STERLING RANCH EAST FILING 5 PRELIMINARY PLAN

LETTER OF INTENT

AUGUST 2023

Please see comments provided by engineering on the Letter of Intent for Sterling Ranch East Filing 5, P237, and update accordingly.

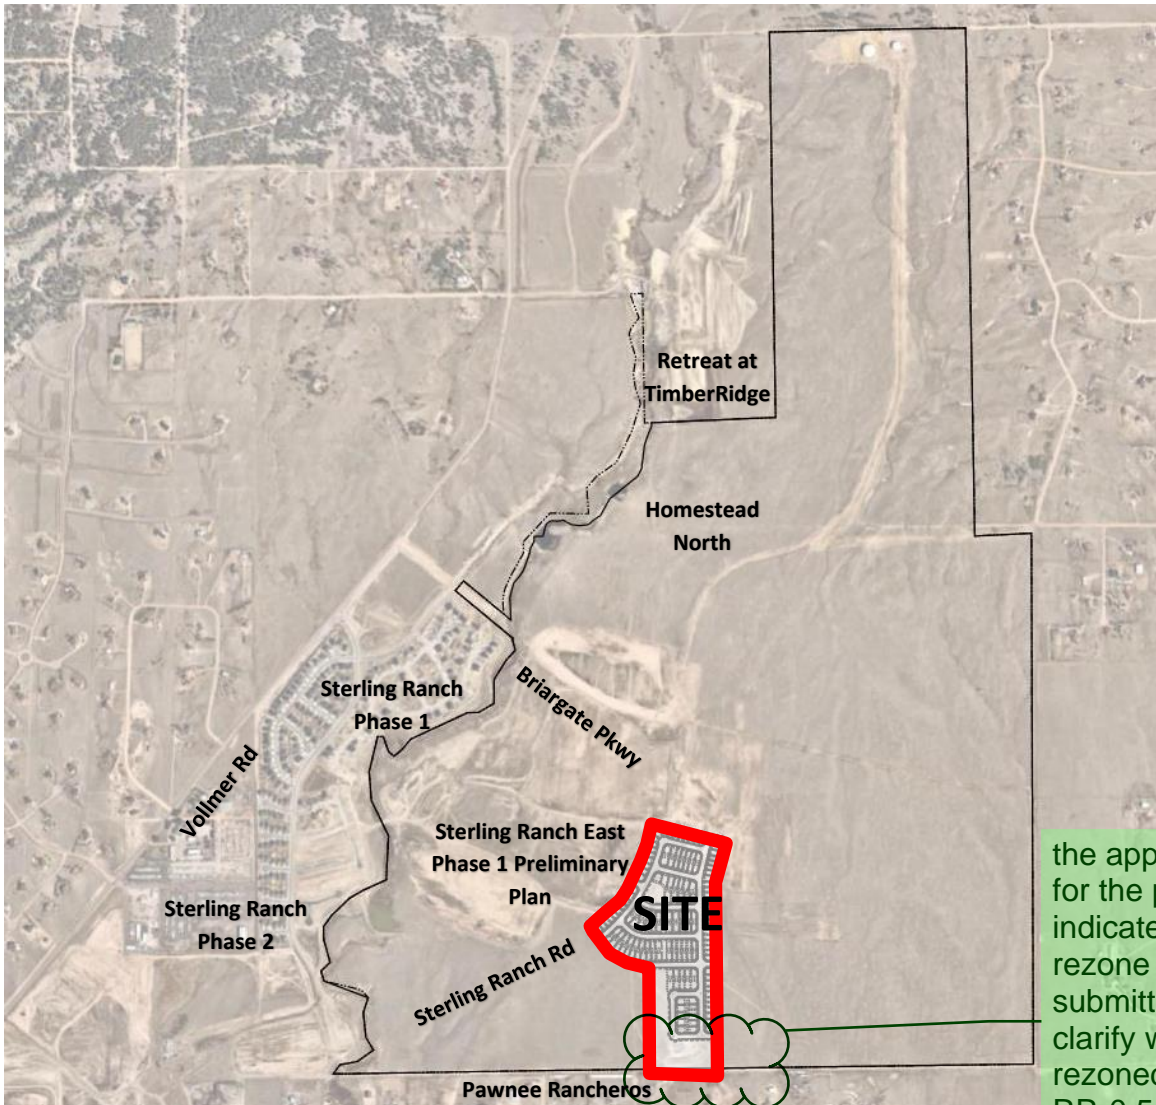
Has the RR0.5 land already been used in another density calculation? It can only be used once- is that why the prelim is larger than the rezone? address please.

- 4. Waiver request from LDC 8.4.4.D. to allow for 27 lots south of Lake Tahoe Drive to be accessed from a single access point as interim condition until future phases of Sterling Ranch provide a connection.

lets discuss this- This is fil 5 east- sterling ranch road is to be completed with filing 1 east so this should not be needed (this is the 5th east plat-2 access points will be needed w this plat after 1-4 are recorded). We did temp access through platted lots that went away w Homestead North which was successful.

Yes, so this needs to be excluded when calculating density.

Agreed, not needed. Removed.
